DSP-18019

Application	General Data	
Project Name: Chick-fil-A, Upper Marlboro Location: On the west side of Robert S. Crain Highway (US 301), at its intersection with Chrysler Drive. Applicant/Address: Chick-fil-A, Inc. 5200 Buffington Road Atlanta, GA 30349	Planning Board Hearing Date:	10/11/18
	Staff Report Date:	09/24/18
	Date Accepted:	06/14/18
	Planning Board Action Limit:	11/08/18
	Plan Acreage:	4.99
	Zone:	I-1 and I-2
	Dwelling Units:	N/A
	Gross Floor Area:	4,999 sq. ft.
	Planning Area:	79
	Council District:	09
	Election District:	03
	Municipality:	N/A
	200-Scale Base Map:	207SE13

STAFF REPORT

SUBJECT: Detailed Site Plan DSP-18019
Chick-fil-A, Upper Marlboro

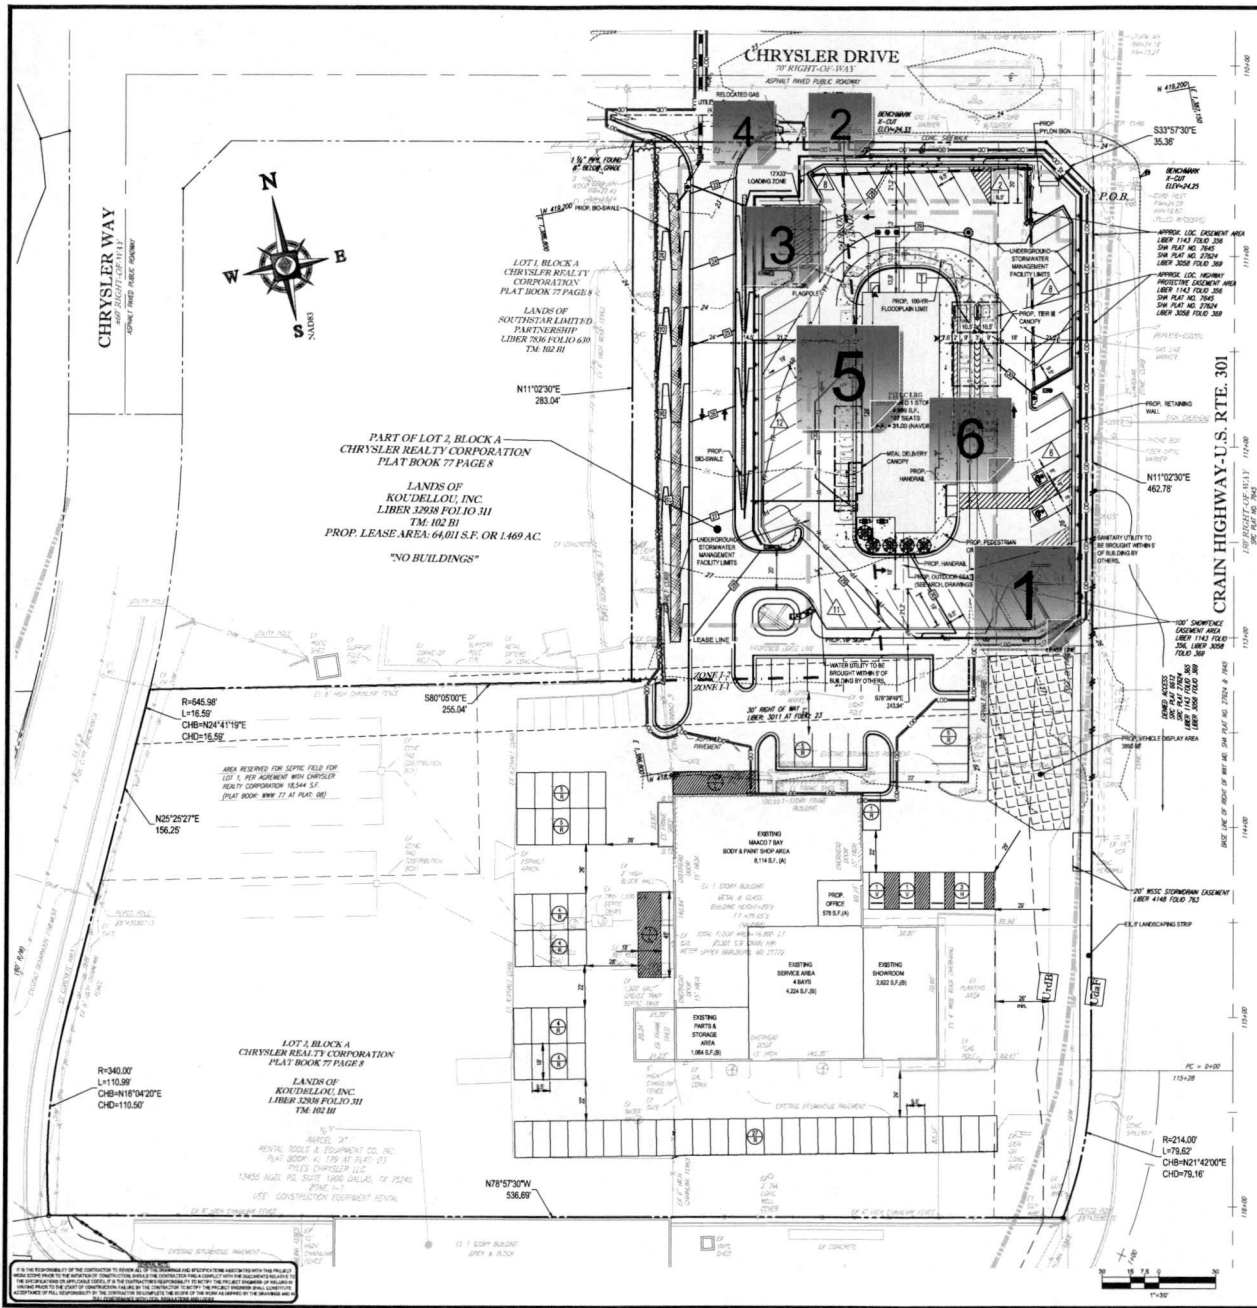
Acquisition of off-site easements from other property owners maybe be required for the proposed sewer) extension. The Applicant is responsible for obtaining the easements. Delineate and show the proposed off-site easement limits on plan. See WSSC Design Manual C-2.1
